PLAN OF PROPOSED IMPROVEMENT

HILL VALLEY - PHASE 1

CITY PROJECT NO. 15668
CONTRACT NO. 9643

REVISION 1 - 9/ 17/ 2025

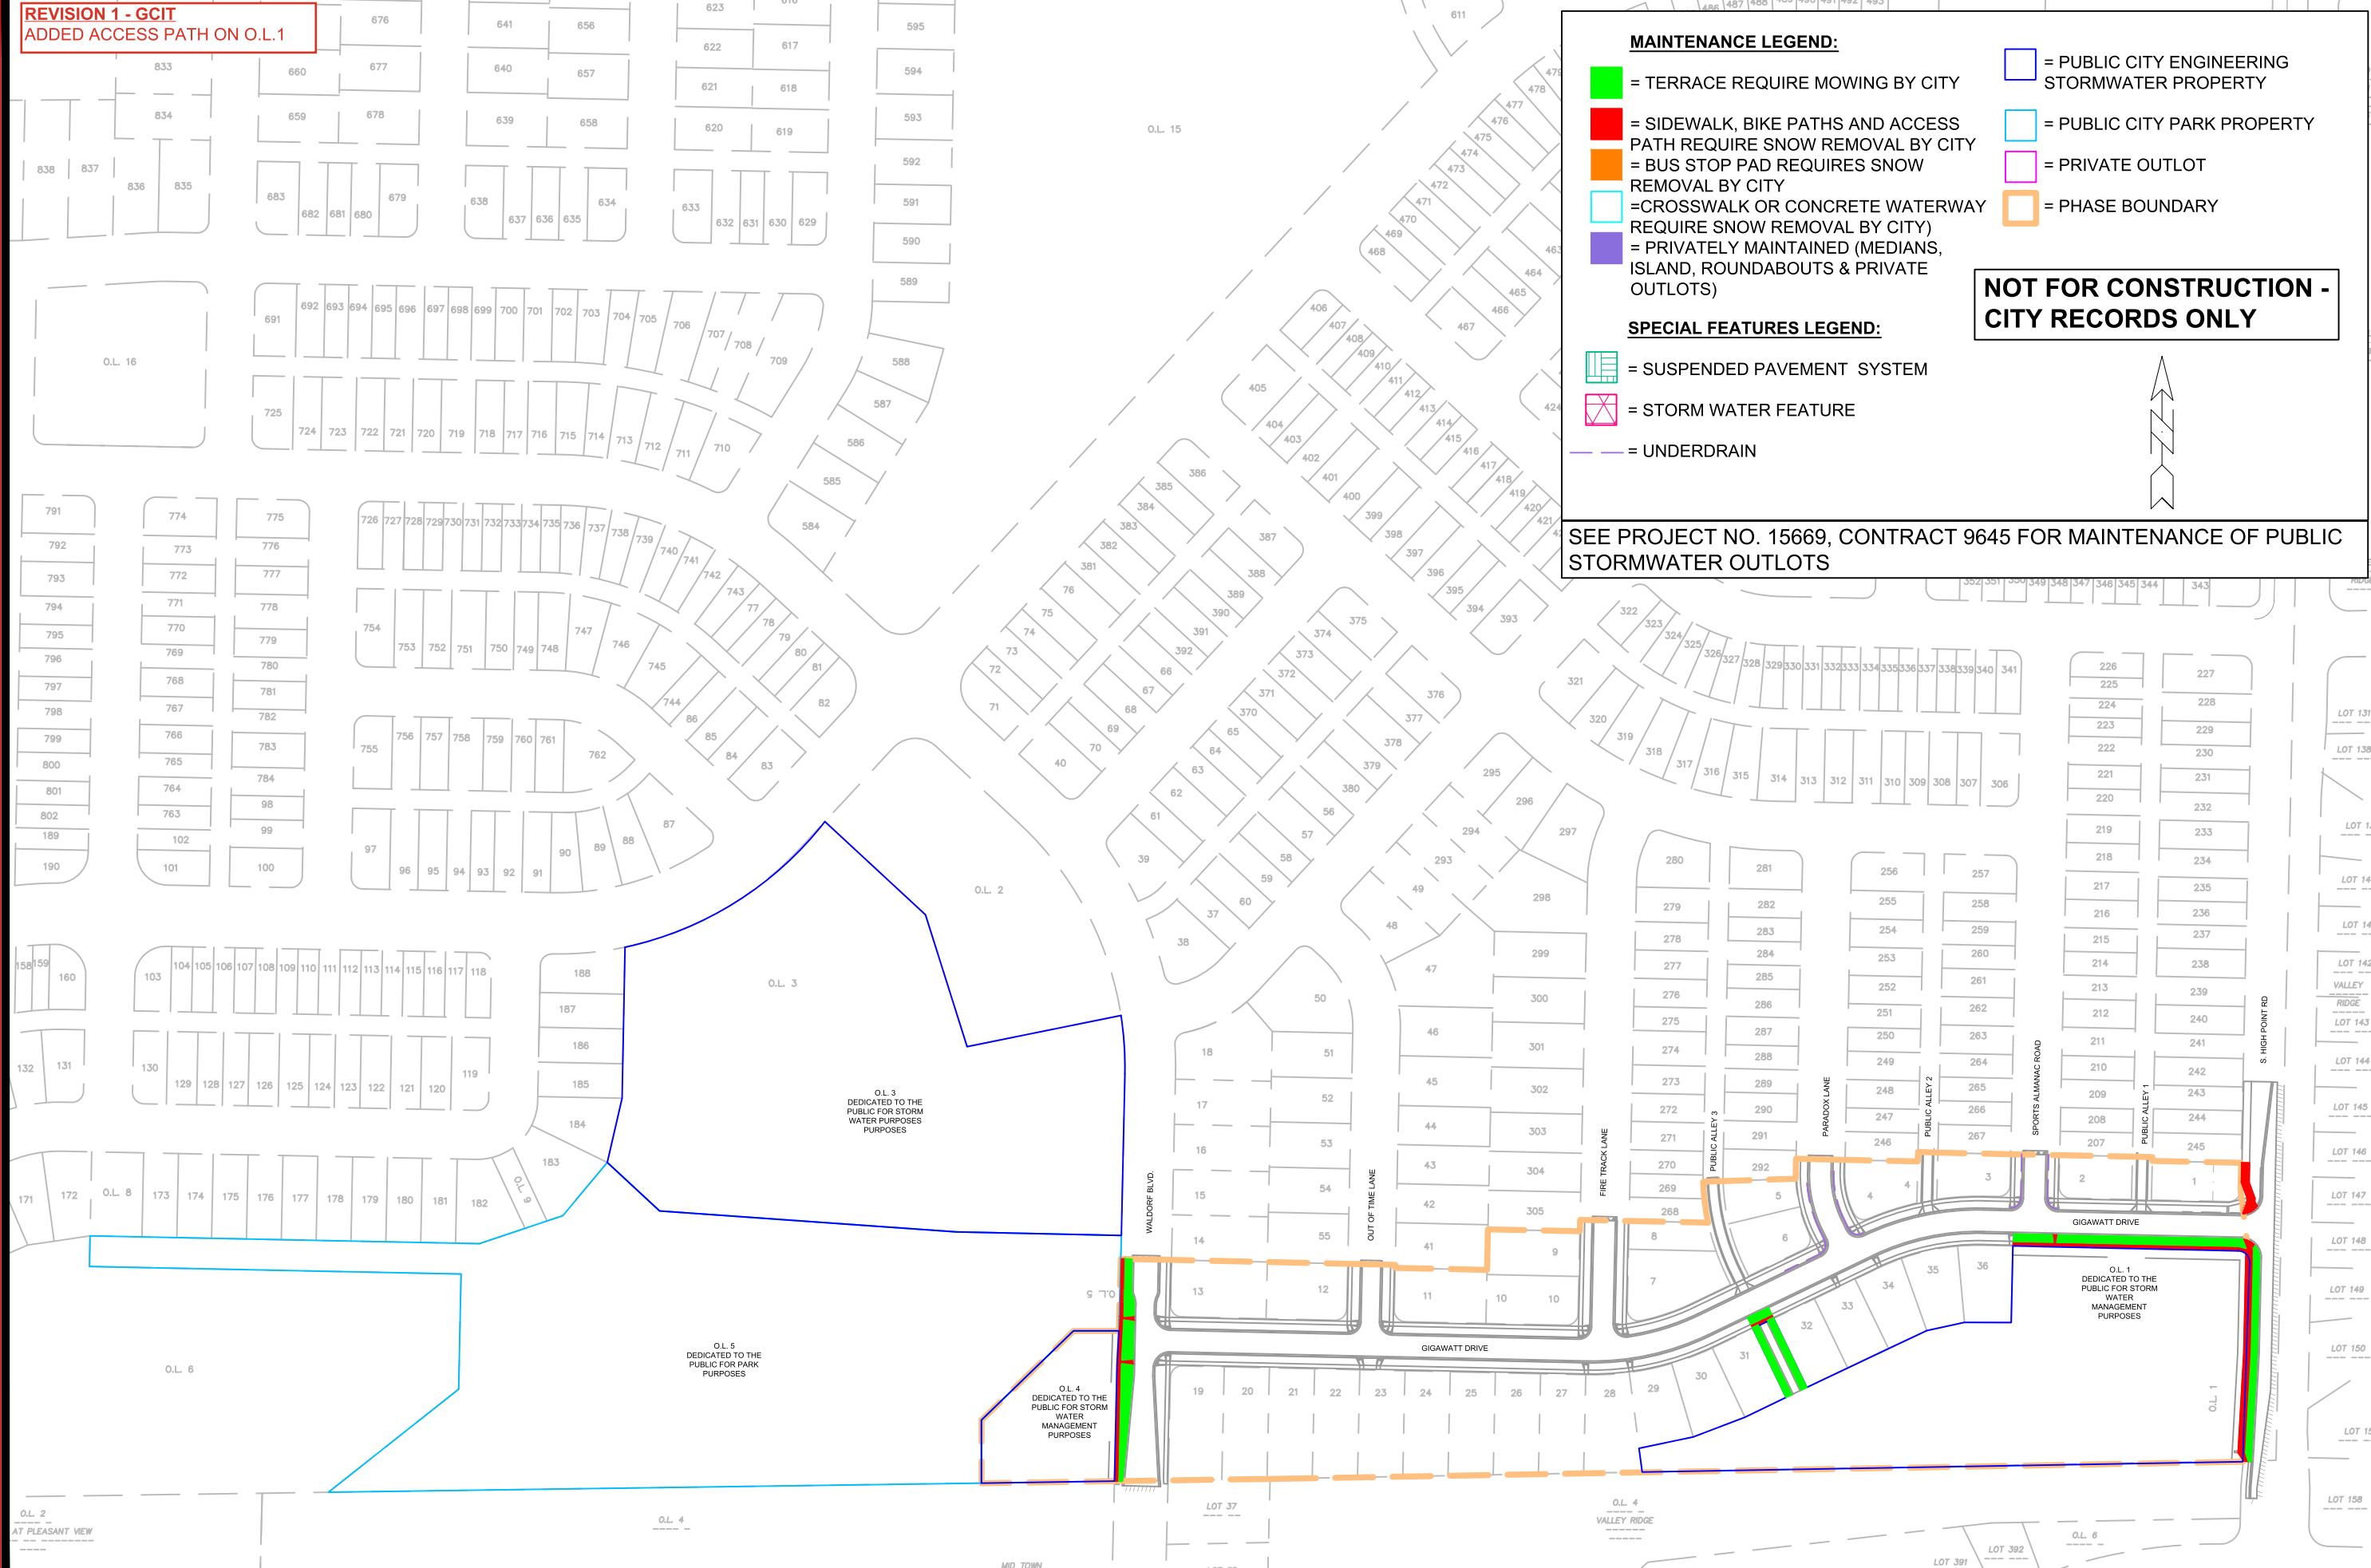
REVISION 1 - GCIT
ADDED ACCESS PATH ON O.L.1
